Drain: OVERMAN-HARVEY DRAIN Drain #: 32
 Improvement/Arm: VILLAGE FARMS-SECTION 4B
 Operator: JDH Date: 5-24-04
 Drain Classification: Urban/Rural Year Installed: 1987

RE: Overman-Harvey Drain
Village Farms - Section 4B (West 1/2 of Section 4)

Map Correction-Field Verification

Drain Name: Overman-Harvey: Village
Farms Sec. 4B

THE VILLAGE FARMS
SECTION III B
PREPARED FOR:
R. L. WILFONG
Carmel, Indiana
PREPARED BY:
WEIHE ENGINEERS INC.
Indianapolis, Indiana

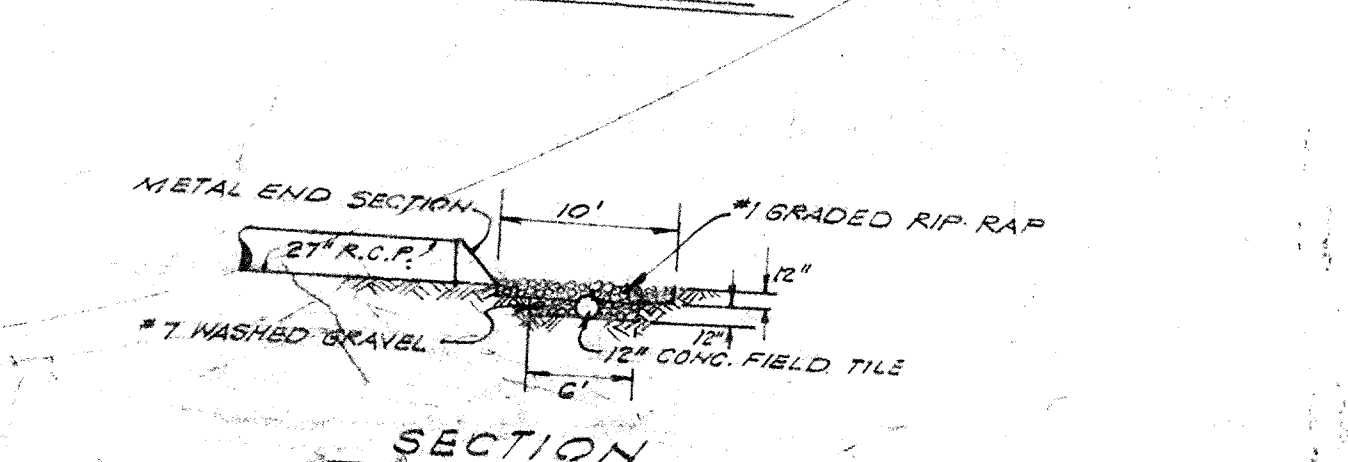
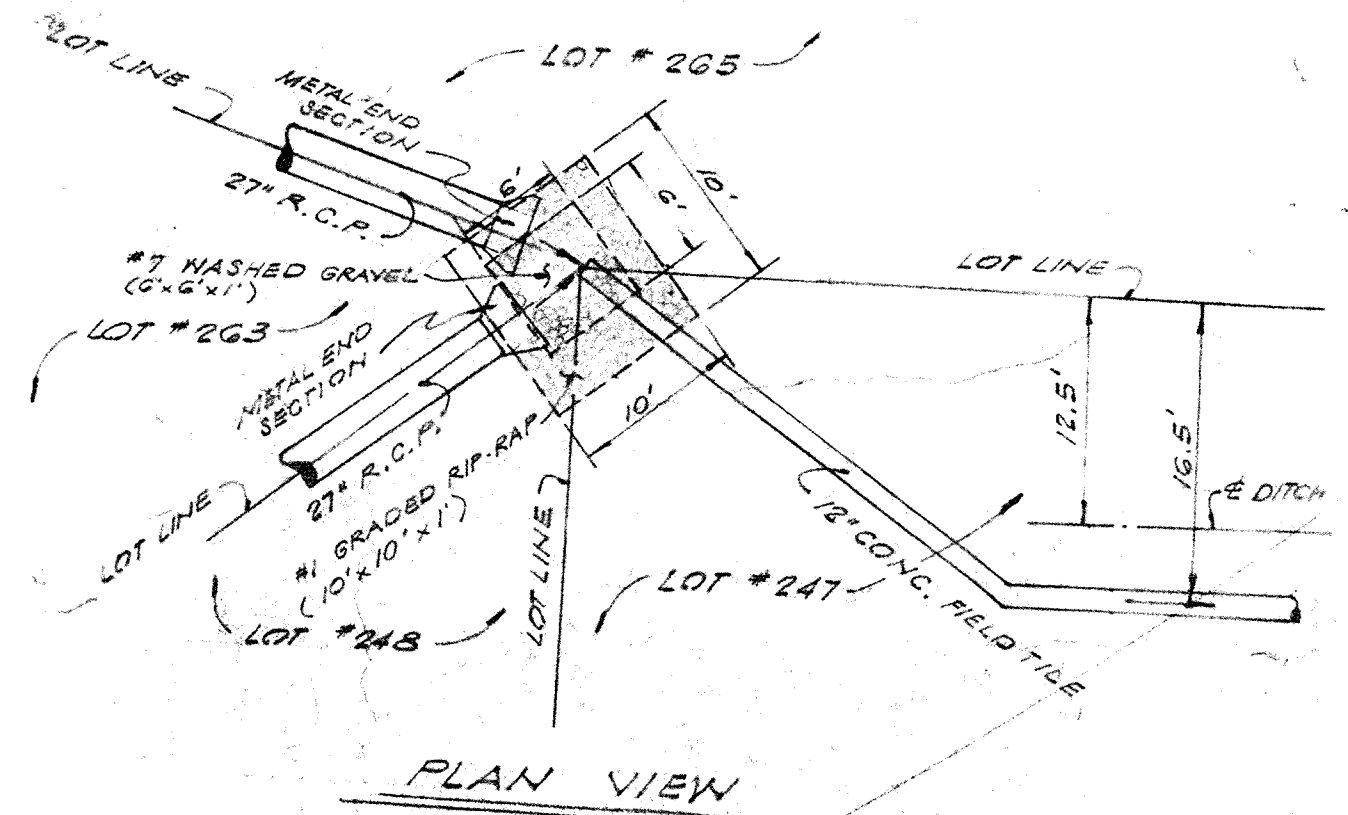
NOTE:
FROM THE N.E. CORNER OF LOT #268,
UPSTREAM THE LEGAL TILE WILL
BE INCORPORATED INTO THE
STORM SEWER SYSTEM.

Note: Storm Pipe along this section revised -
see Sheet #2 Section Six Village Farms

Note: Storm Pipe along this section revised -
see Sheet #2 Section Six Village Farms

Village Farms
Sec. 4B

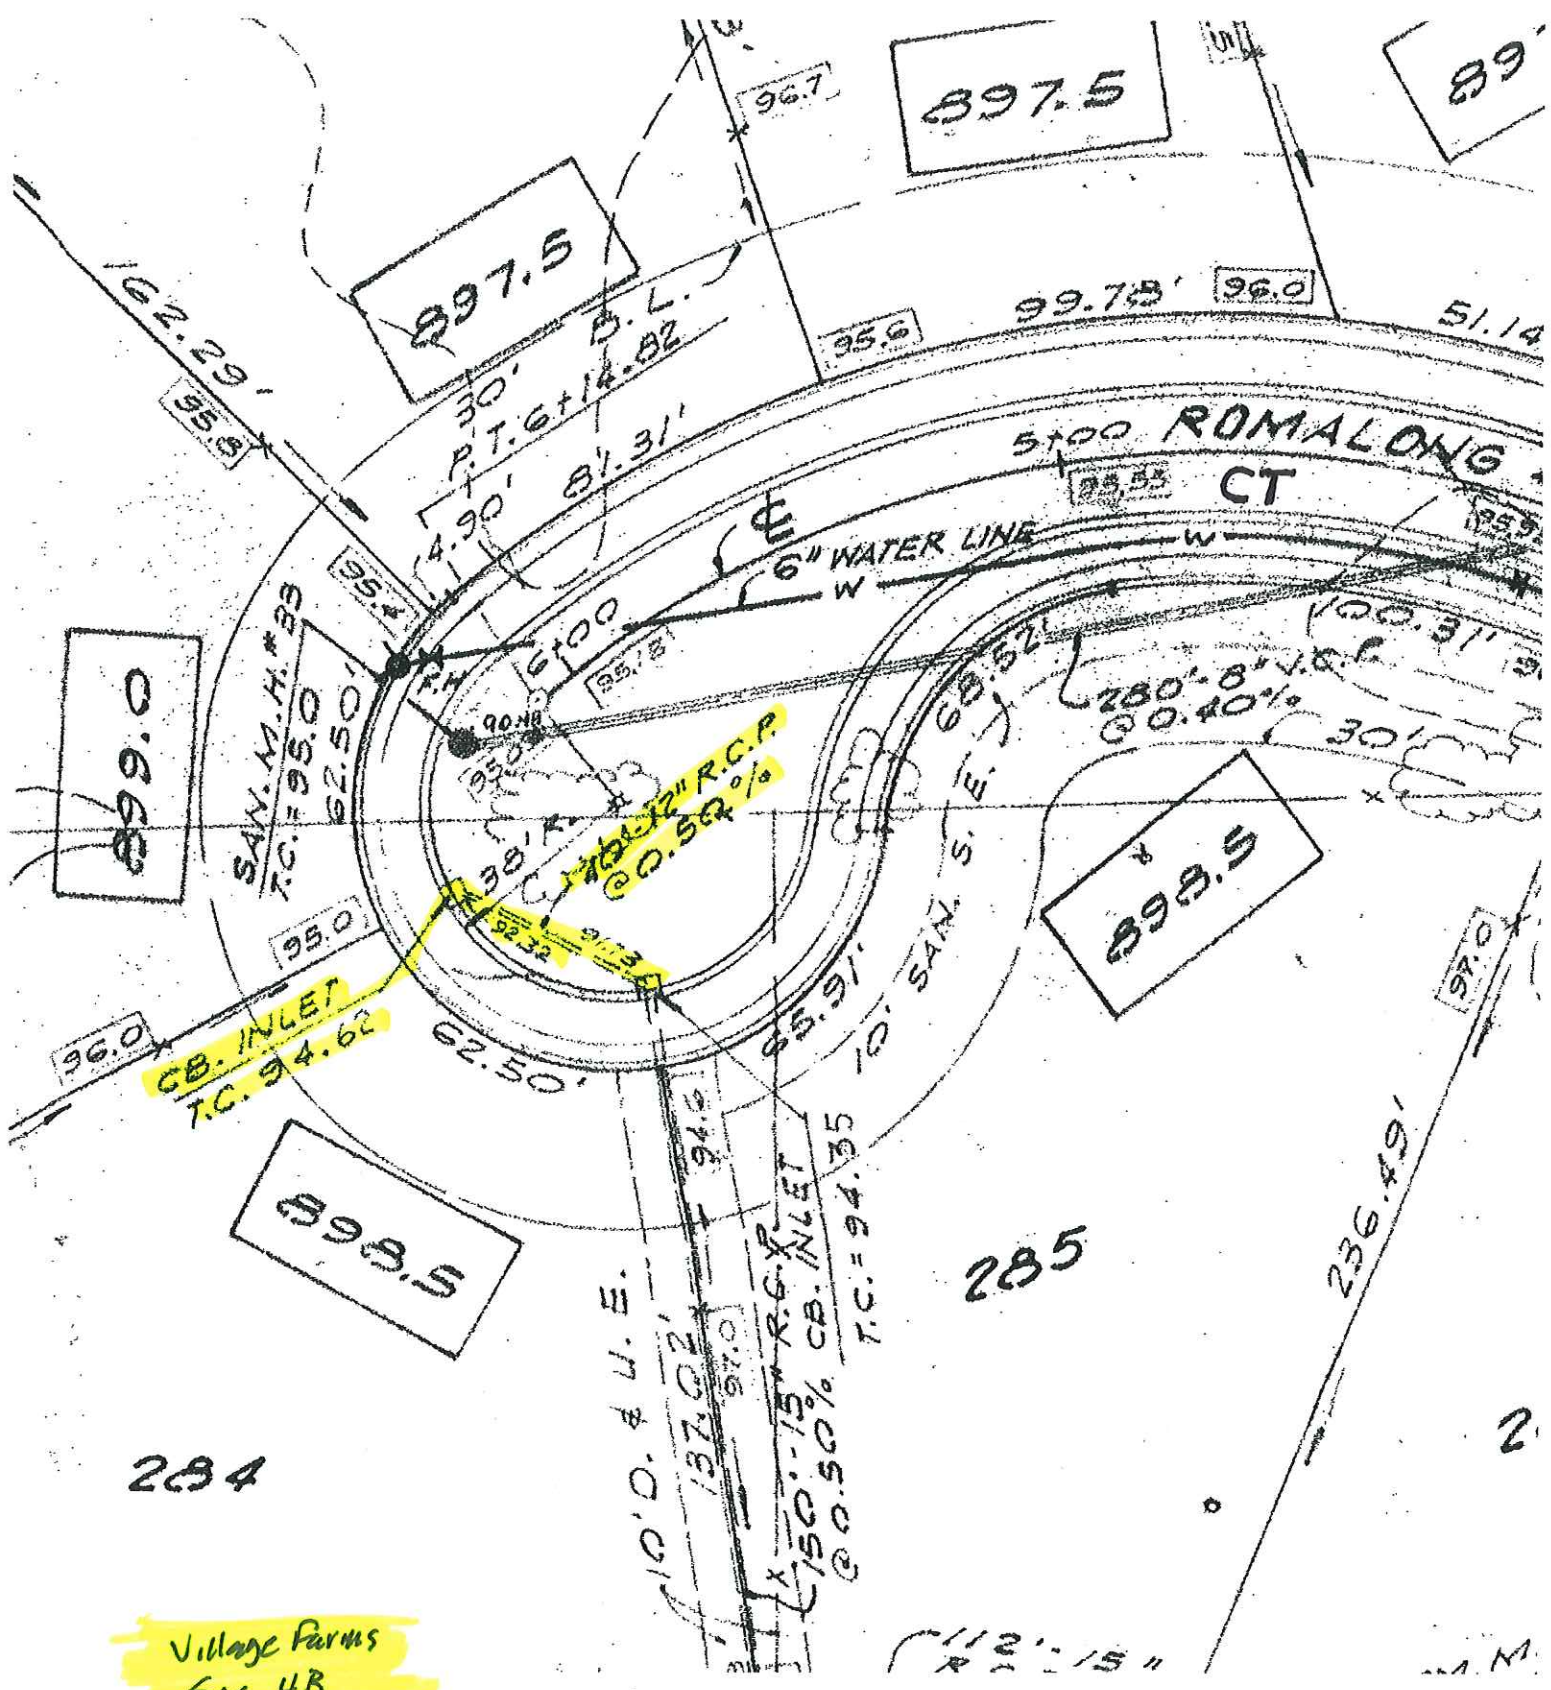
See attached map. When this drain was mapped in the GIS in 2004, we missed 40' - 12" RCP between structures 105A to 105. This section of pipe was discovered by Steve Baitz during a recent site visit & work order.

Change +/- : (+) 40

New Length: 4151
